DAVE BAXTER
Vice President
Oconee Nuclear Station

Subject: Duke Energy Carolinas, LLC
Oconee Nuclear Station, Units 1, 2, and 3
Docket Numbers 50-269, 50-270, and 50-287
Request for Additional Information regarding the License Amendment Request to
adopt NFPA 805 Performance-Based Standard for Fire Protection for Light Water
Reactor Generating Plants (2001 Edition)
License Amendment Request (LAR) 2008-01

1. Request for Additional Information regarding the License Amendment Request to adopt NFPA 805 Performance-Based Standard for Fire Protection for Light Water Reactor Generating Plants (2001 Edition)

Figure 1 - Timeline

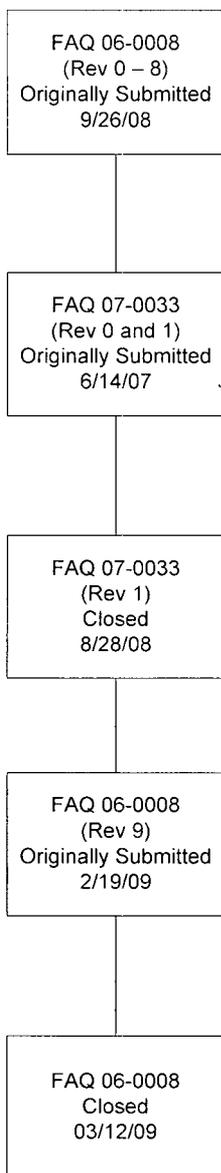
NEI 04-02, Section 4.1.1, "Transition Process Overview," notes that the licensee will review EEEE's during the transition process to ensure the quality level and the basis for acceptability is still valid. Satisfactory results from this review will provide an adequate basis to transition EEEE's for the deterministic requirements of Chapter 4 of NFPA 805. In accordance with 10 CFR 50.48(c) and NFPA 805, EEEE's which evaluate deviations from NFPA 805, Chapter 3, requirements must be submitted to the NRC for approval.

Unless specifically limited by the Chapter 3 element, these evaluations should be completed, at a minimum, for all power block areas. (Note that certain standards, such as NFPA 600, apply to the entire plant.)

The scope of the Engineering Equivalency Evaluations (EEEs) required to be included in the LAR has changed since ONS submitted the LAR. Figure 1 below depicts the timeline and bases for this conclusion.

ONS will revise the TR, specifically Attachment J – EEEE Transition. Attachment J – EEEE Transition will be revised to remove all engineering evaluations currently listed. The engineering evaluations currently listed in Attachment J are allowed and do not need to be submitted in the LAR for NRC approval.
